## Memorandum

**Re:** Interstate 80/Gilman Street Interchange Improvement Project  
– Addendum to the Technical Reports  
District 04 - ALA - 80 - PostMiles 6.38 / 6.95  
EA 04-0A7700 / Project ID# 0400020155

### 1.1 ADDENDUM OF FIGURE REVISIONS

Figure 1-2. Map of the Project and Nearby Roadways

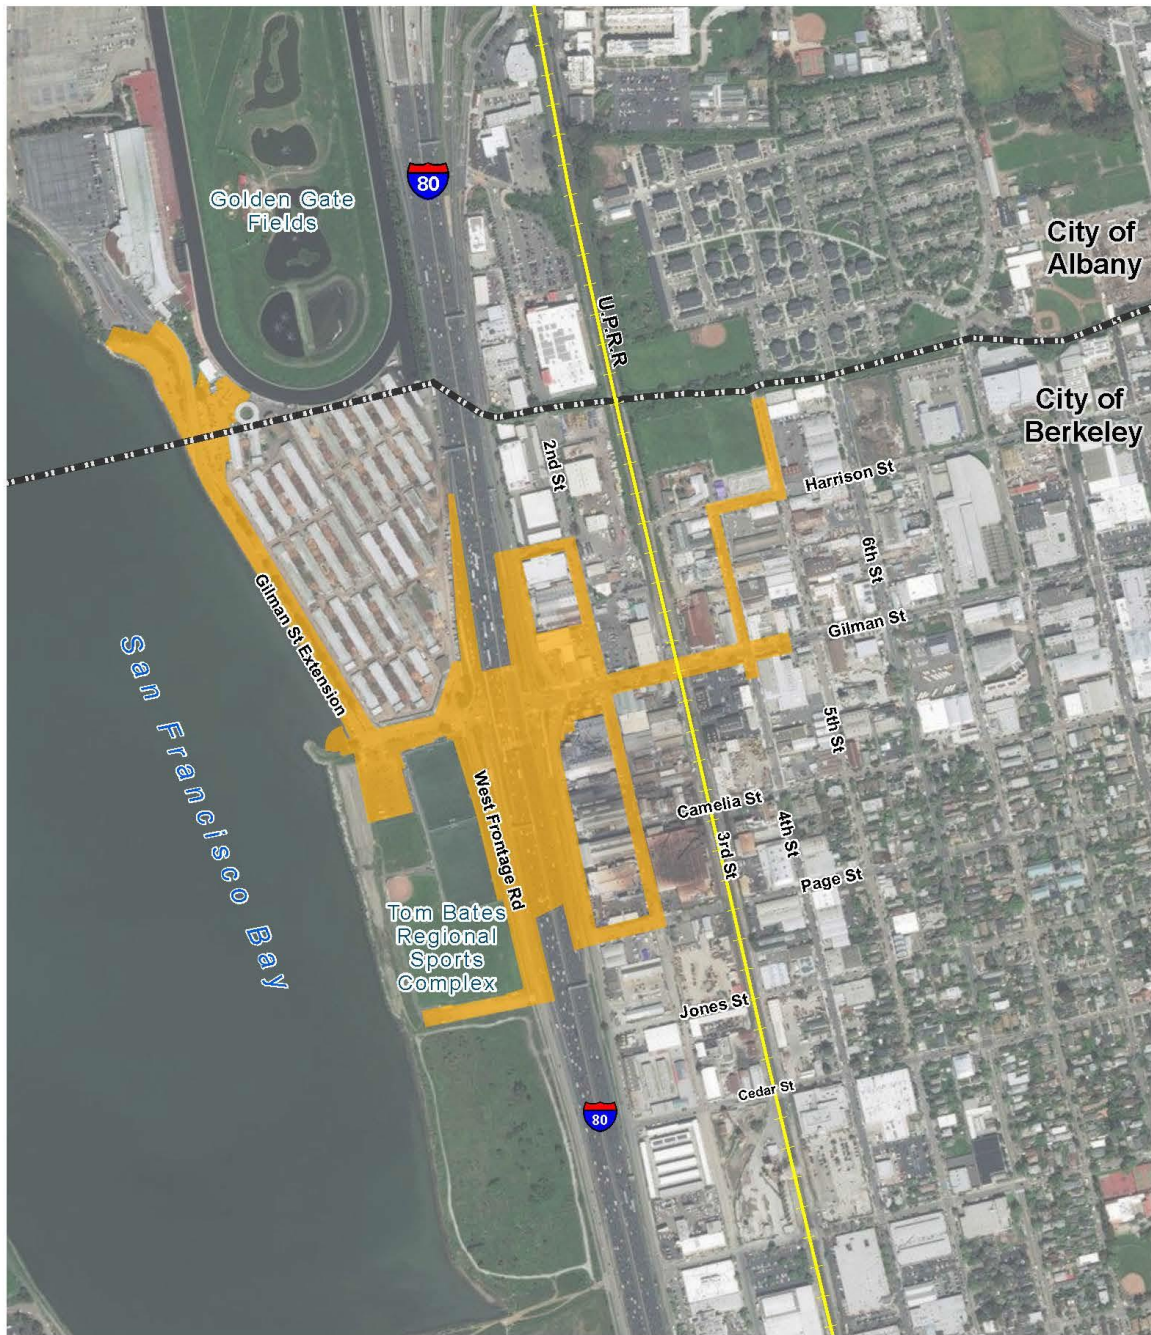
This addendum updates the project footprint and study area boundary depicted in various figures in the technical reports prepared for the Interstate 80 (I-80)/Gilman Street Interchange Improvement Project. This revision to the project footprint and study area boundary does not result in any change in the affected environment or potential impacts, and the findings presented in the previously approved technical reports remain valid. The technical reports, figure number, and figure name included in this addendum are identified below. The revised figures are attached at the end of this memorandum.

Figure 1-2. Map of the Project and Nearby Roadways

Figure 3-2. Map of Air Quality Monitoring Station Nearest to the Project

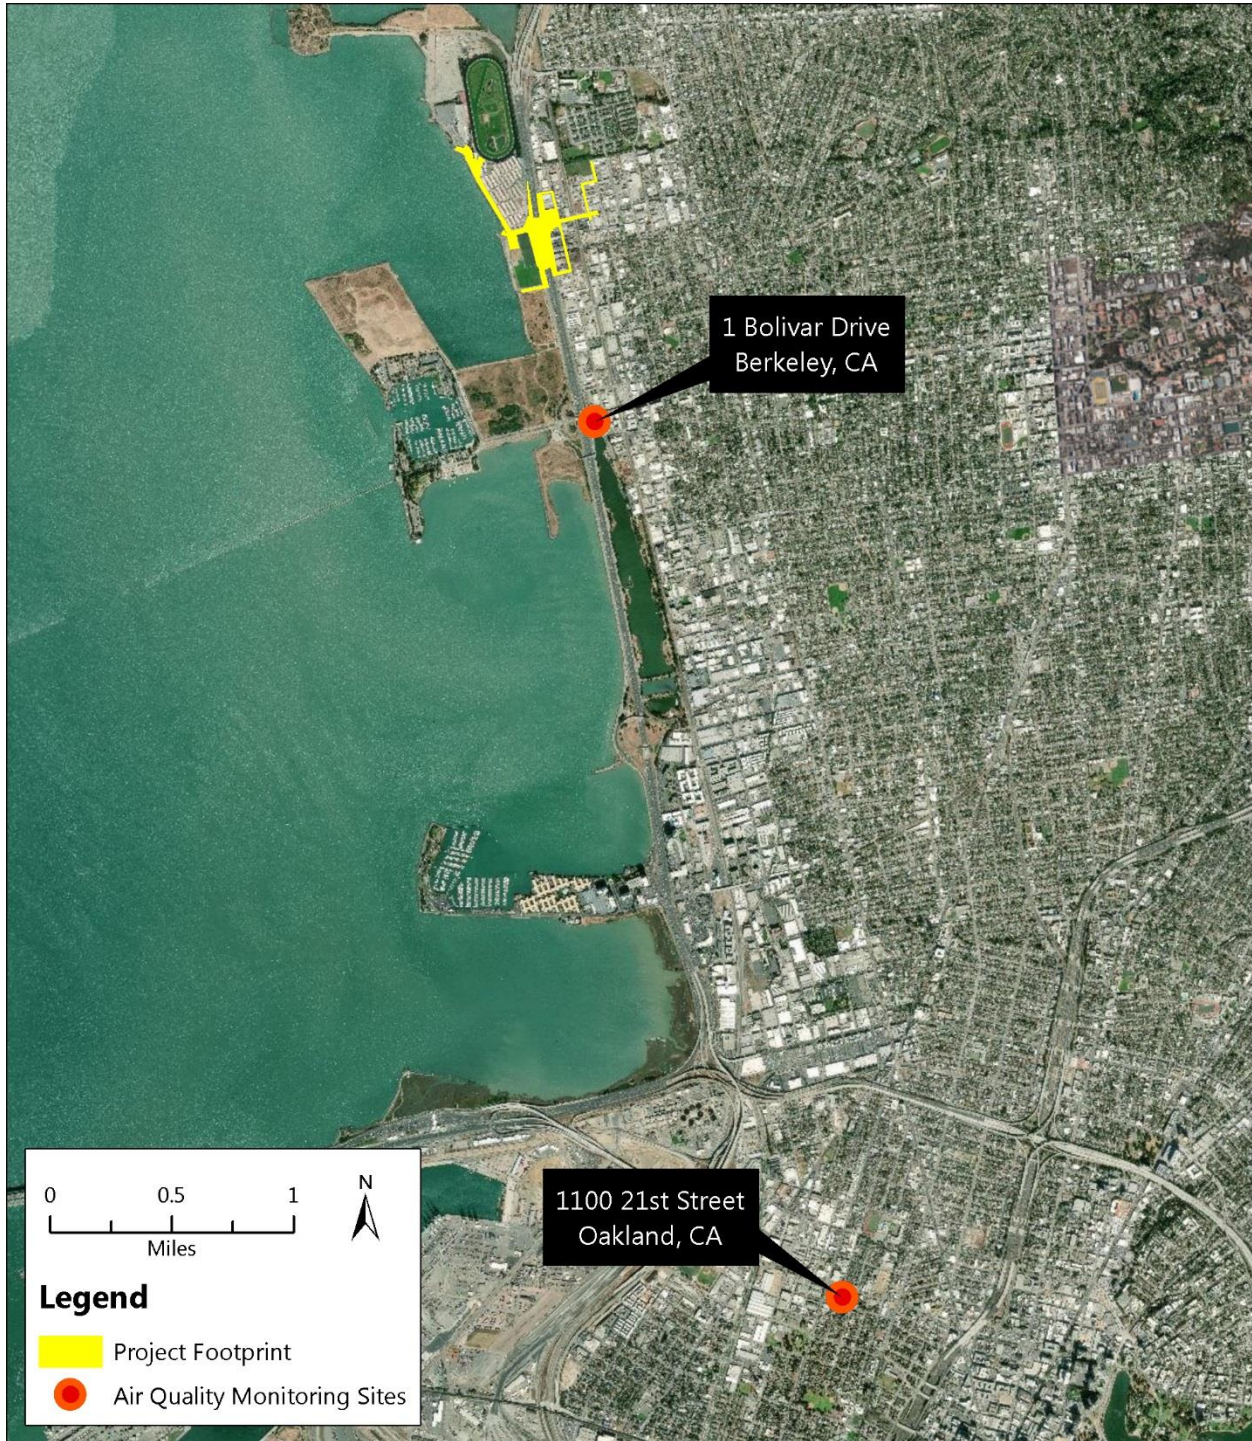
Figure 3-2. Map of Air Quality Monitoring Station Nearest to the Project

Figure 3-3. Sensitive Receptors Located Near the Proposed Project

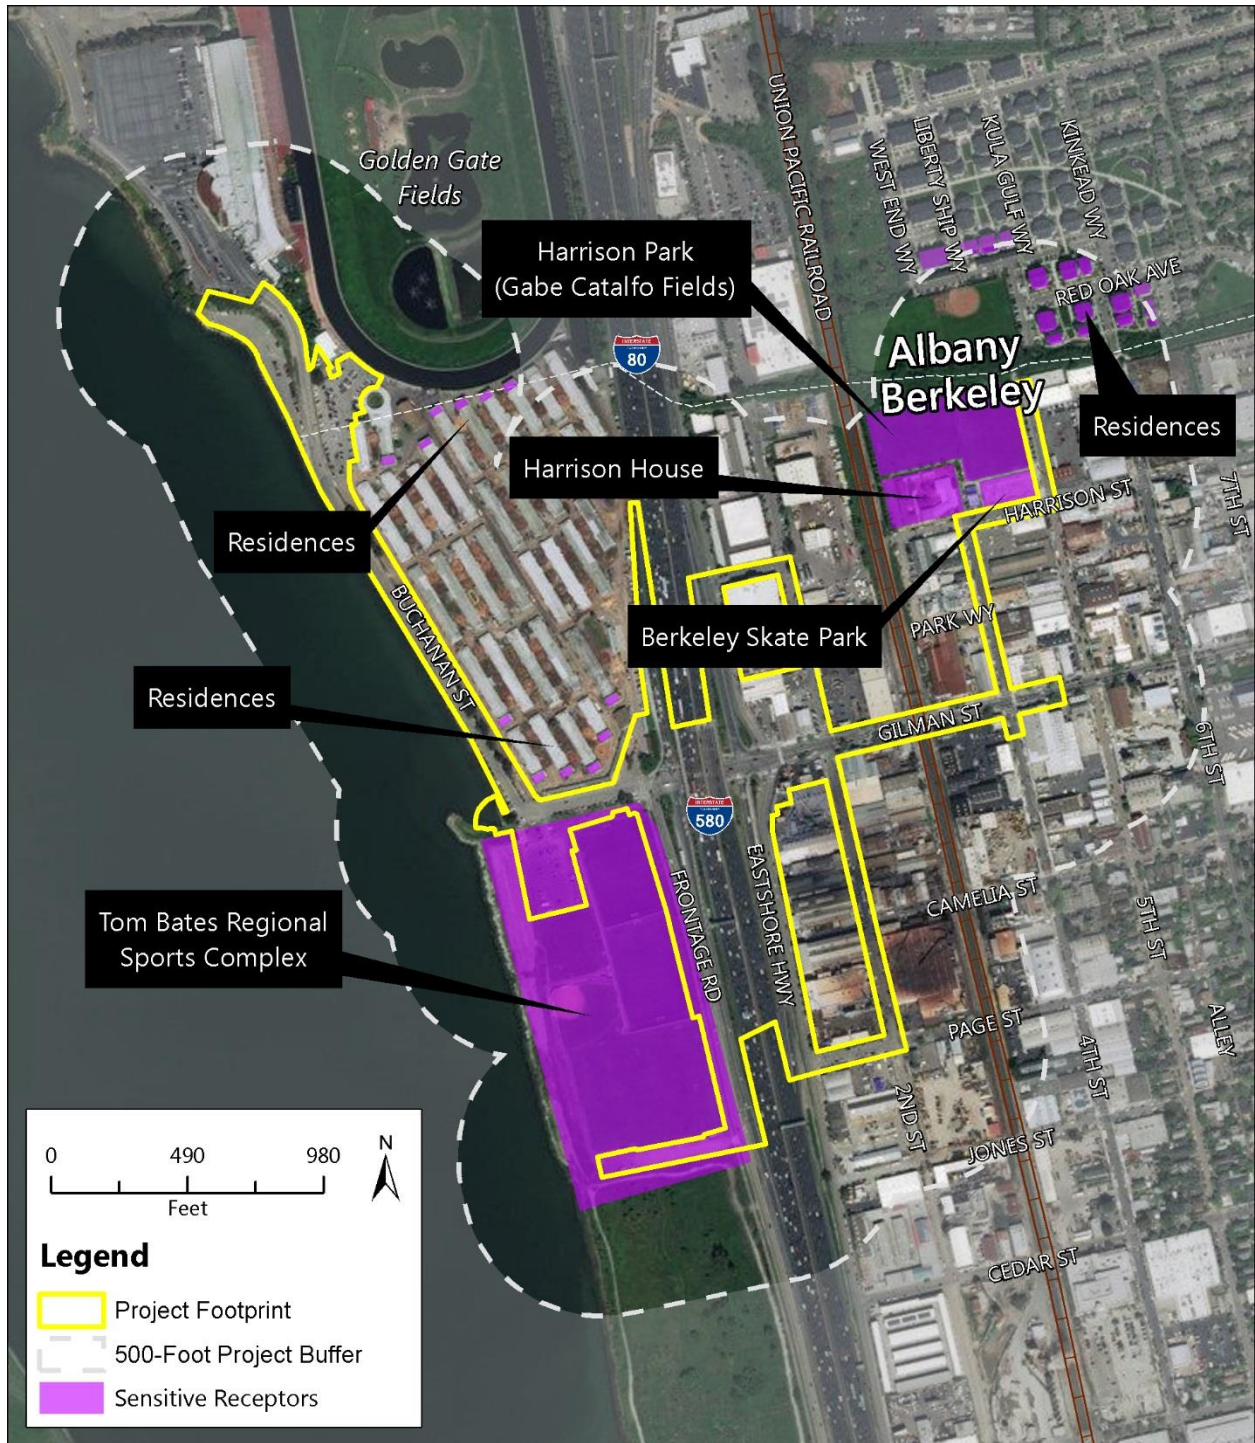
Figure 3-3. Sensitive Receptors Located Near the Proposed Project

Figure 1-2: Project Location

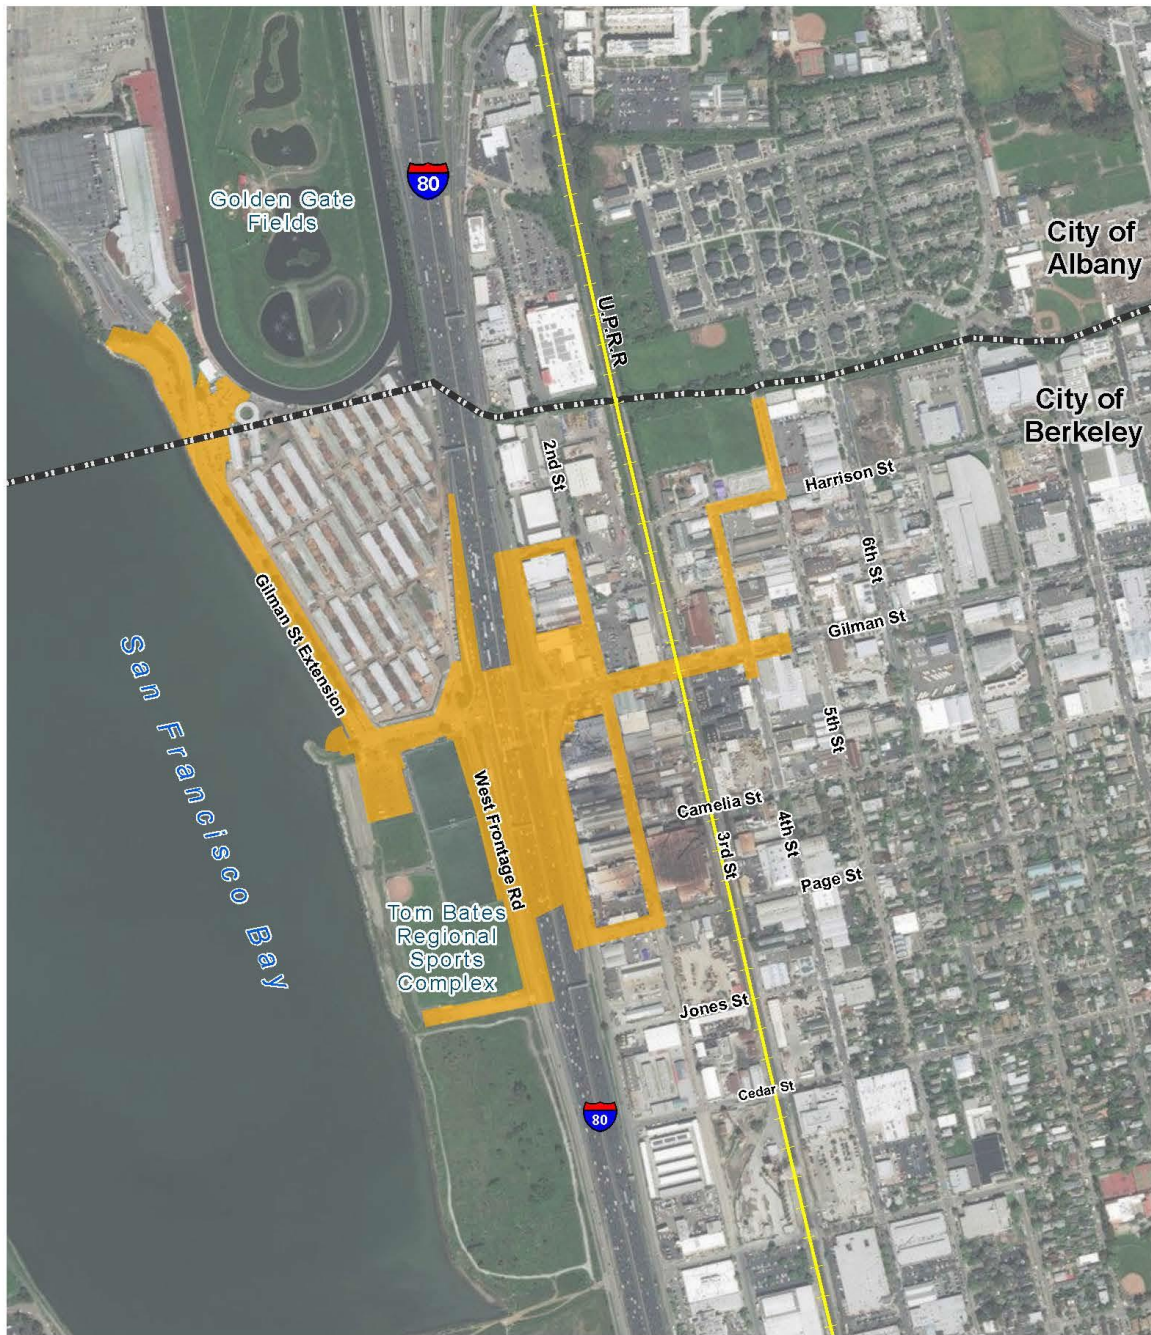
Figure 1-2: Project Location

Figure 2-1: Existing Land Use

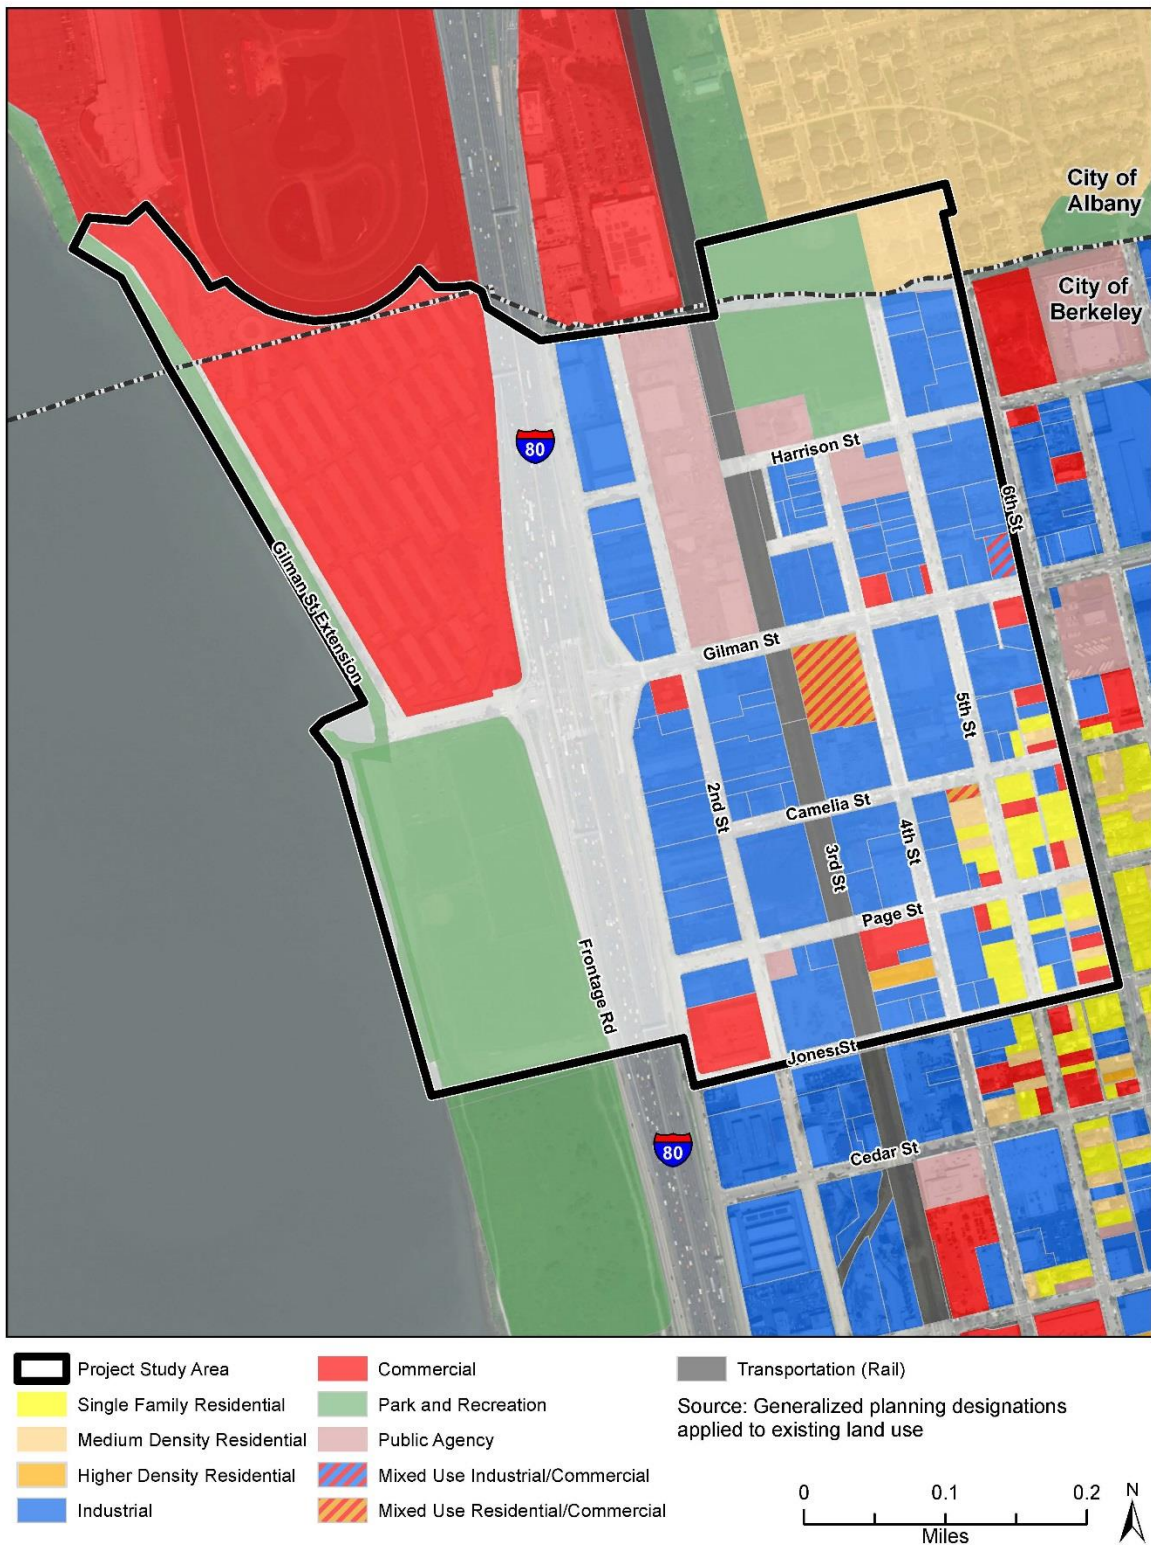
Figure 2-1: Existing Land Use

Figure 2-3: Parks and Recreational Facilities

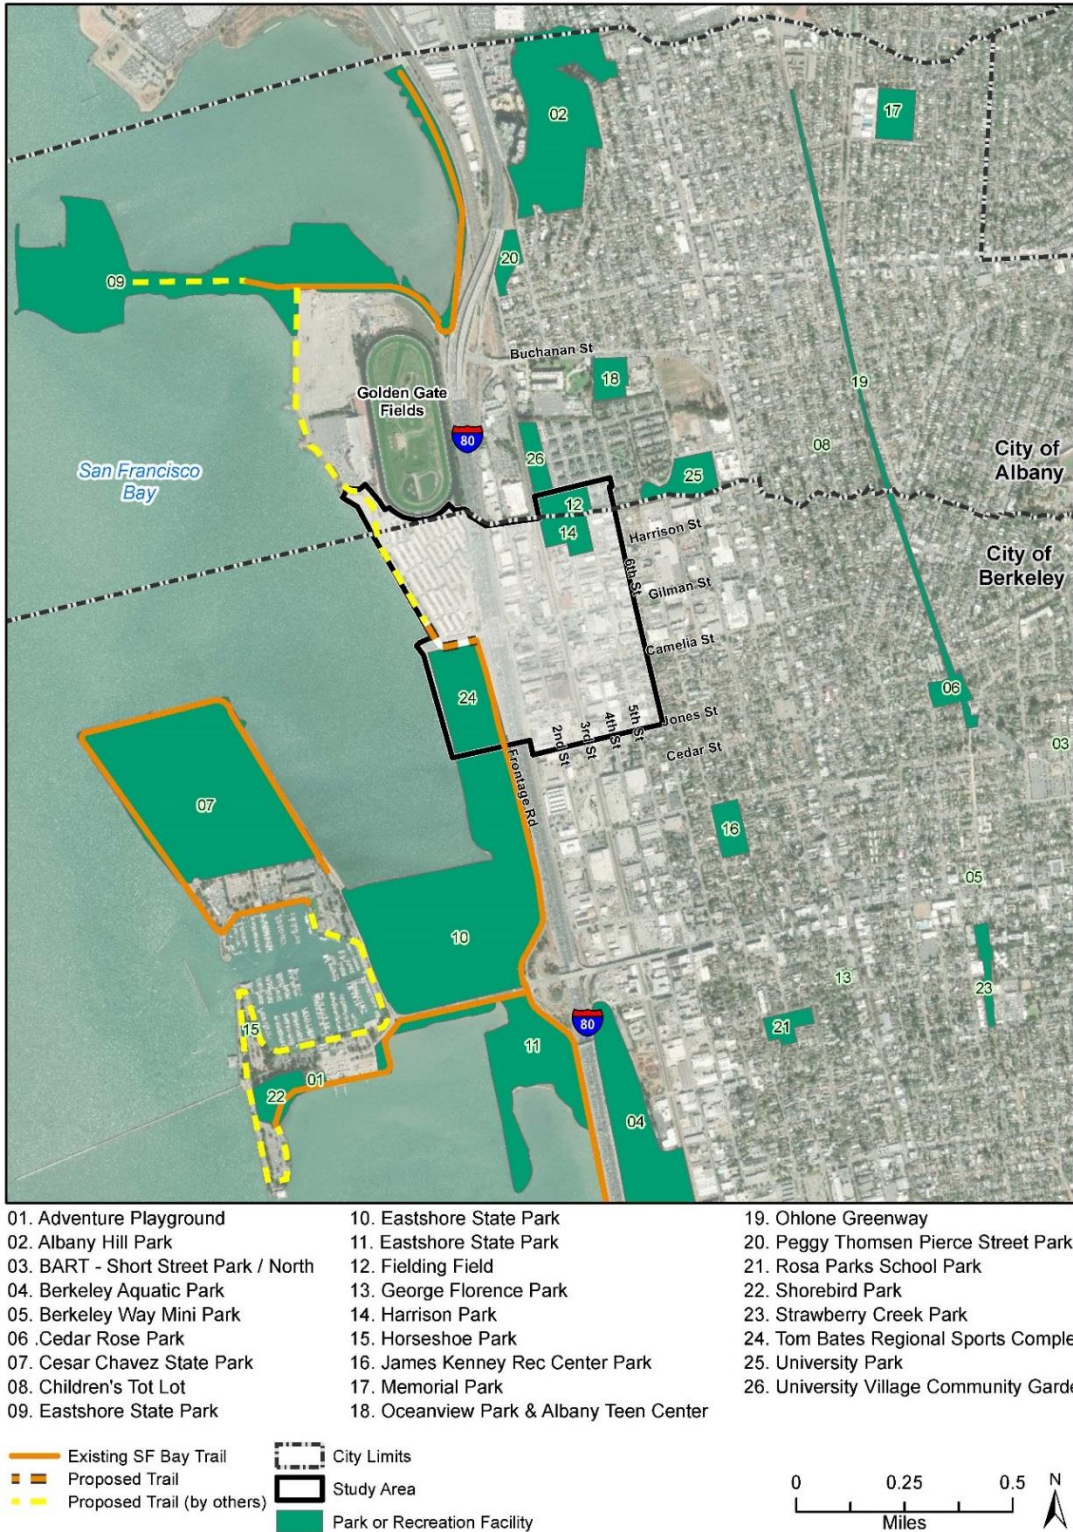
Figure 2-3: Parks and Recreational Facilities
